COMMISSION DIRECTIVE 2005/12/EC

amending Annexes I and II to Directive 2003/25/EC of the European Parliament and of the Council on specific stability requirements for ro-ro passenger ships

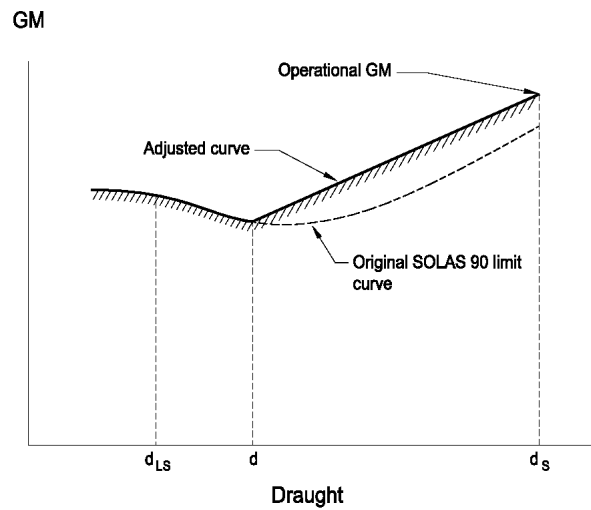
- 3.2.5. In order to ensure that the model motion characteristics represent those of the actual ship it is important that the model is both inclined and rolled in the intact condition so that the intact GM and the mass distribution are verified. The mass distribution should be measured in air. The transverse radius of gyration of the actual ship should be in the range 0,35B to 0,4B and the longitudinal radius of gyration should be in the range 0,2L to 0,25L.
